COUNCIL ASSESSMENT REPORT

Panel Reference	PPSSCC-77
DA Number	DA 1037/2020/JP
LGA	The Hills Shire Council
Proposed Development	Demolition of existing structures and construction of four residential flat buildings containing 292 units, 362 car spaces, neighbourhood shop, pocket park and the provision of a pedestrian cross through link.
Street Address	125-127 Showground Road, 4-10 Carrington Road, 15A-23 Sexton Avenue, Castle Hill
Applicant	Ecospective Fifth Land Pty Ltd
Consultant/s	LJB Urban Planning Turner Architects Australis Tree Management Turf Design Studio Ason Group Efficient Living Wood & Grieve Engineers/Stantec Adams Engineering Design Confidence McKenzie Group Haron Robson Douglas Partners Intrax Consulting Engineers Veris Australia Construction Consultants Barker Ryan Stewart
Date of DA lodgement	31 January 2020
Number of Submissions	Six
Recommendation	Approval
Regional Development Criteria (Schedule 7 of the SEPP (State and Regional Development) 2011	CIV exceeding \$30 million (\$119,054,817)

Report prepared by	Cynthia Dugan - Principal Coordinator Development Assessment
Report date	Electronic Determination

Figure 4: Levels 6 - 9 plan

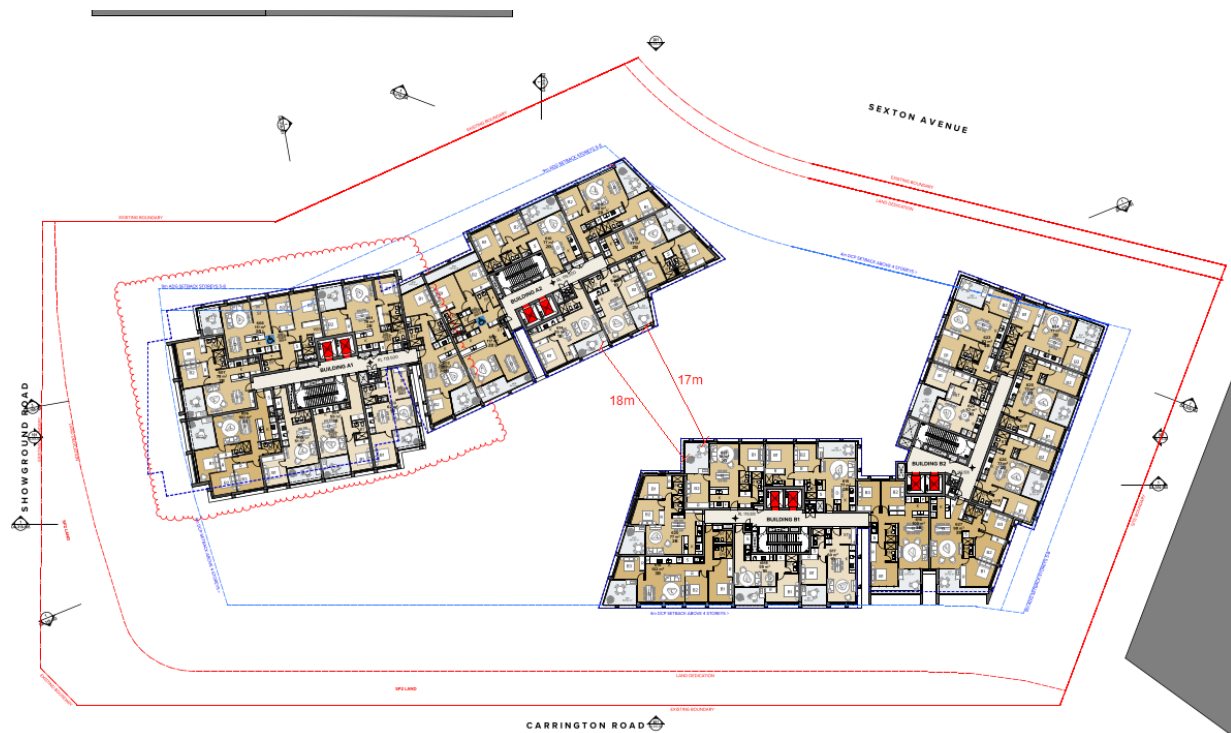
The proposal complies with the internal building separation design criteria of the ADG for the majority of units with the exception of the separation distance of balconies and habitable room/balconies within inward facing units in Building A2 and B1. Refer to figures below.

Figure 7: 3 bedroom units indicating balcony depth non-compliance

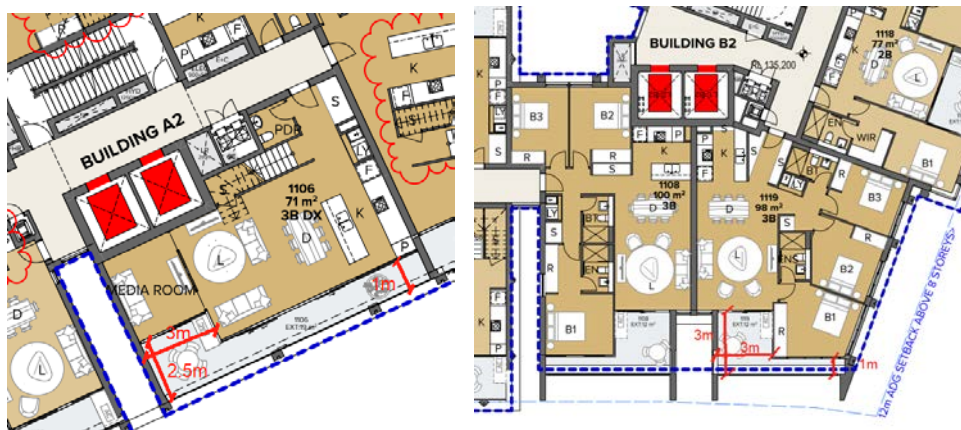
Whilst all balconies comply with the ADG minimum balcony area requirements, 17 balconies do not achieve the 2m minimum depth for the minimum area required for 2 bedroom units and 13 balconies do not achieve the 2.4m minimum depth for the minimum area required for 3 bedroom units. Refer to figures below.

The intent of the balcony depth design criteria is to ensure balcony areas are useable, can be easily accessed and provides enough space for a small table for 2 bedroom units and a larger table for 3 bedroom units. It is considered that whilst each of the non-compliant 2 bedroom balconies have a minimum dimension of 1m, each balcony comprises an area with a suitable depth of at least 2m to allow for useable space for a small table. The non-compliant 3 bedroom balconies would require the relocation of air conditioning units to allow enough space for larger tables. In this regard, a condition is recommended that the air conditioning units in units 516, 527, 616, 627, 716, 727, 816, 827, 916, 927, 1016, 1027 and 1106 are relocated to the narrowest depth of the balcony to ensure adequate useable space is provided. Refer condition 1.

Figure 8: Applicant's diagram indicating exceedance to height standard including detail of Building A1/A2

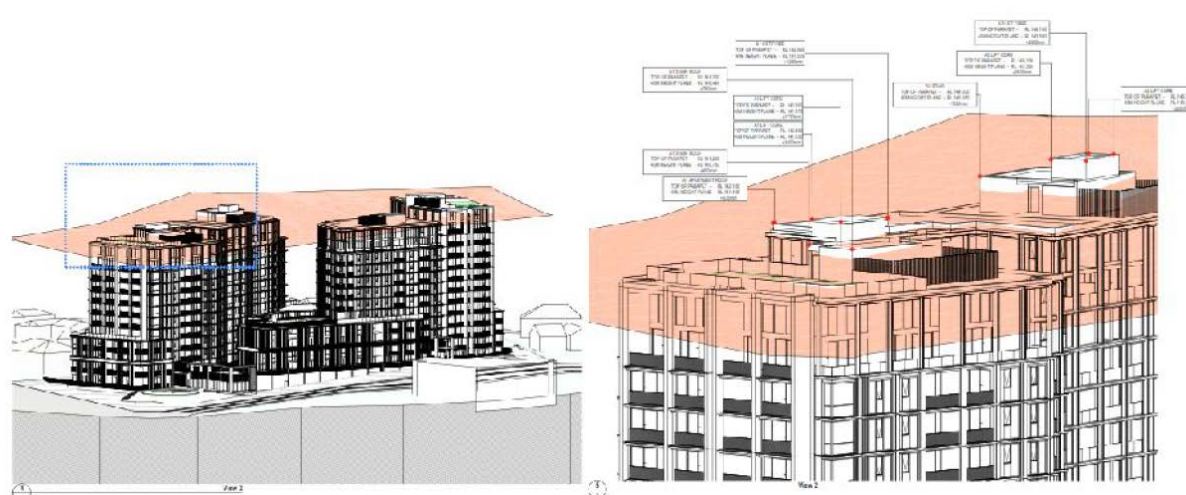
The proposed departure to the building height development standard is generally limited to lift overruns, stair parapets and acoustic screens and will not cause adverse impacts on the amenity of adjoining properties with respect to overshadowing, privacy, view loss and perceived bulk and scale. The habitable floor space of the development generally complies with the height standard with the exception of 635mm (1.5%) to Building A1 for 2 units and 1.9m (4.75%) to Building B2 for 3 units.

It is considered that the small scale of the acoustic screens and stair parapets will not be discernible from the streetscape and will result in negligible overshadowing and amenity impacts to the existing and future developments to the south.

Figure 9: Applicant's diagram indicating exceedance to height standard including detail of Building B1/B2

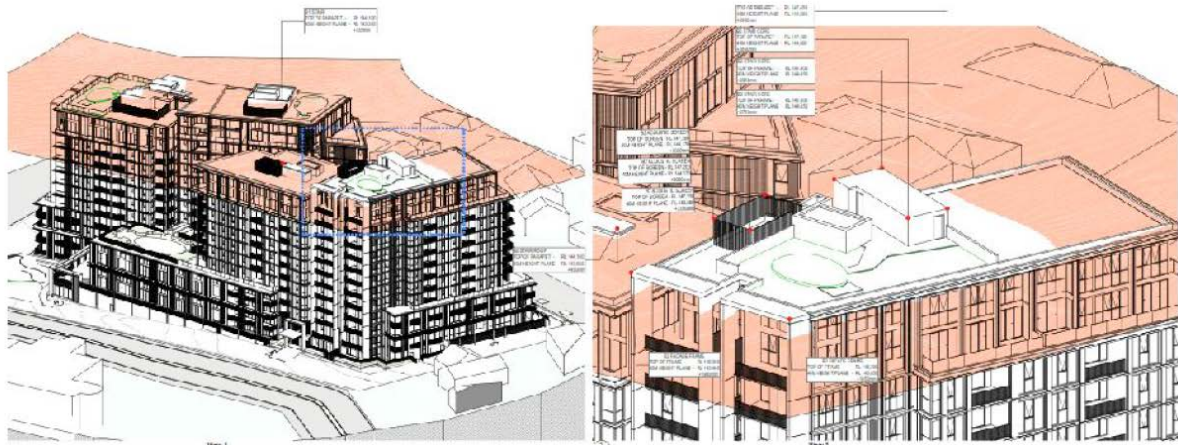
Building B2 comprises a 3.32m (8.3%) exceedance to the height standard for an acoustic screen and a 2.95m (7.37%) exceedance to the stairs. Whilst this is located to the south of the roof plan, the Applicant has submitted shadow diagrams demonstrating that this variation results in negligible overshadowing impacts compared to that of a fully compliant scheme.

The exceedance to the height standard for Building A2 occurs to lift overruns and stair parapets providing access to the rooftop communal open space area and acoustic screens for plant equipment. The height exceedance to Building B1 occurs to the stair parapets to access the roof for maintenance purposes. The lift overruns, stair parapets and acoustic screens on these buildings are centrally located and would not result in additional overshadowing impacts to adjoining development and would result in negligible visual amenity impacts when viewed from the street or adjoining development. The acoustic screens serve as a functional and aesthetic measure to screen unsightly mechanical plants to enhance visual amenity to the built form.

Figure 14: Variations to front and upper level setbacks

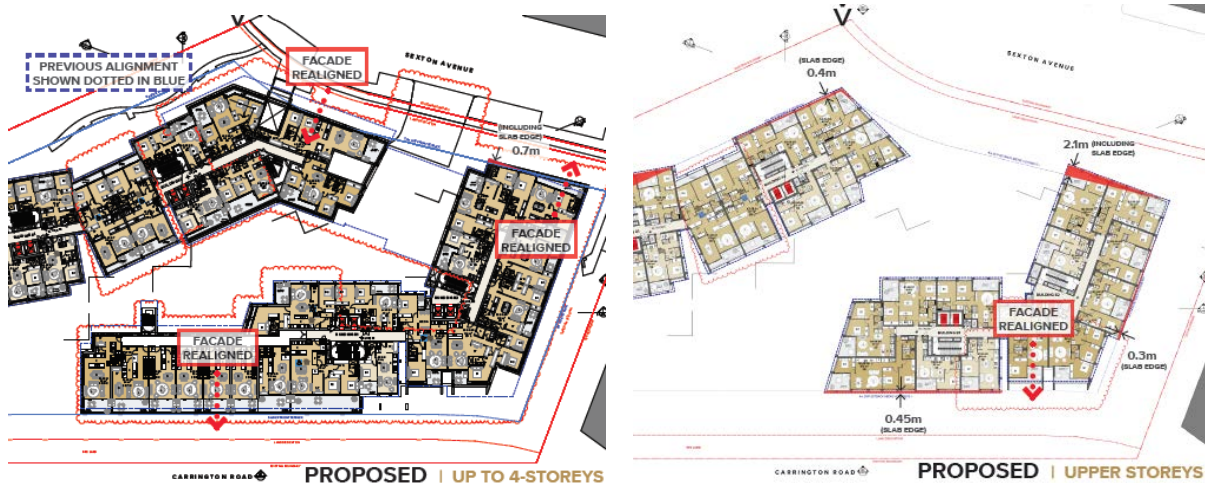
Minor encroachments occur to the Sexton Avenue front setback and Carrington Road upper level setback as depicted in the below diagrams. Refer Figure 14. The encroachments that occur on Sexton Avenue are point encroachments due to the irregular shape of the lot as a result of the curvature of the road. The encroachments of 0.4m for Building A2 and 0.7m for Building B2 are for slab edges to balconies. The encroachments are considered negligible compared to that of a fully compliant scheme. Similarly, the 0.45m encroachment to the upper level setback for Carrington Road for a slab edge is considered negligible compared to that of a fully compliant scheme.

Despite the variations to the front setback controls, the proposed buildings when viewed from Sexton Avenue and Carrington Road still provide for a high quality architectural design, articulation zones that complement each building and emphasize entry points and attractive building facades integrated with landscape screening. Residential amenity is not compromised and sufficient solar access and privacy is provided for residents.

Figure 15: Amended façade lengths fronting Carrington Road and model depicting architectural treatment on facades

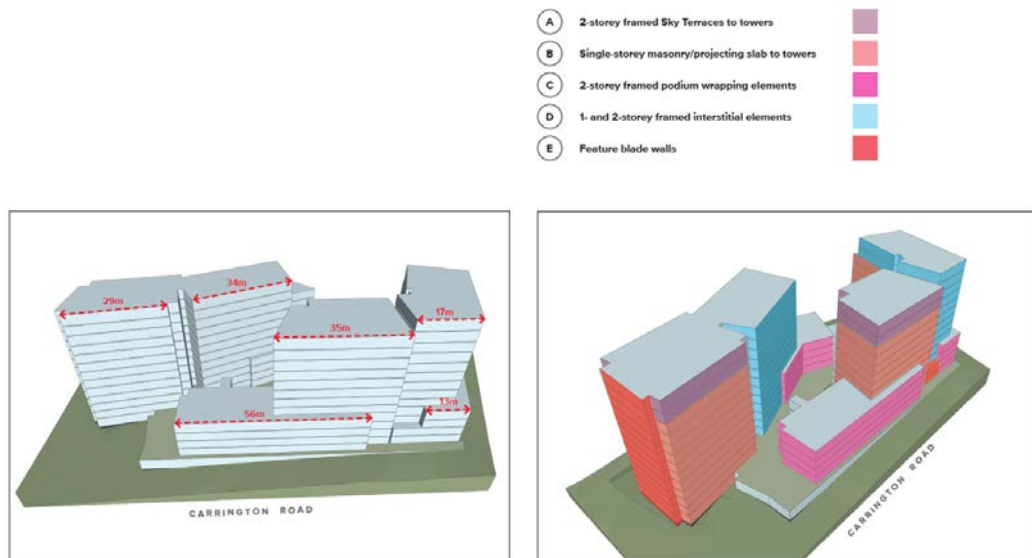
Whilst the proposal results in a maximum building length of 81m for Building B1/B2, the following diagram has been submitted by the Applicant that demonstrate that the maximum façade lengths are less than 65m. A model indicating the diversity in architectural treatment is also provided below.

Whilst Buildings B1/B2 exceed the total building length, the variation is limited to the lower podium. The two storey framed podium wrapping elements are distinct from the mass of the B1 tower element. Similarly, the B2 tower includes indentations that also break up the building mass. This provides adequate modulation, differing architectural expression and well-articulated built forms. The use of horizontal and vertical framing elements, openings and fenestration as well as varying materials and colours differentiate between a distinct base and top results in high-quality architectural façades. The diversity in balcony forms includes louvred screens to add visual interest to the facades and linear banding elements provides a balanced juxtaposition to create an interesting design.

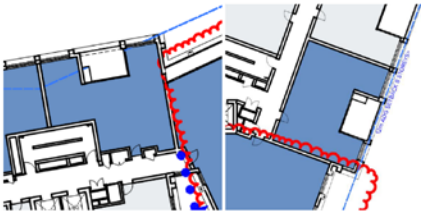
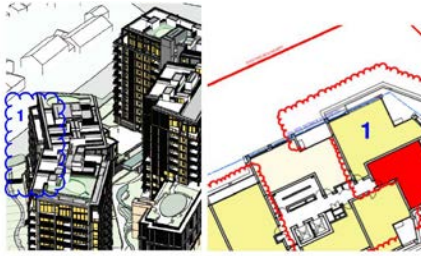
Cross ventilation non-	The cross ventilation of the units has	Issue addressed.

ISSUE/OBJECTION	COMMENT	OUTCOME
compliance with the Apartment Design Guide. Example of non-compliance below. 	been assessed as satisfactory and complies with the requirements of the ADG. Refer to Section 3b. of this report. The examples included in the submission appears to relate to units 627, 727, 827 and 927 in Building B which is a corner unit comprising 3 windows as shown on the eastern elevation and two windows as shown on the southern elevation. In this regard, sufficient cross ventilation would be provided for these units.	
Solar Access non-compliance with the Apartment Design Guide. No glass is visible in the 3D views taken at 11am in mid-winter. 	The solar access of the units has been assessed as satisfactory and complies with the requirements of the ADG. Refer to Section 3b. of this report. The examples included in the submission appear to relate to the south eastern corner units in Building A2 (units 511, 611, 711, 811, 911, 1011). The ADG requires that living and private open spaces of at least 70% of apartments are to receive a minimum of 2 hours direct sunlight between 9am and 3pm midwinter. The north elevation (Drawing No. DA-210-101) indicates that the north eastern facing windows are full height windows serving living rooms. The 3D solar model submitted with the application demonstrates that the units in question would receive 2 hours of direct sunlight to the living room and private open space between the hours of 9am and 11am in midwinter. In this regard, sufficient solar access would be provided for these units.
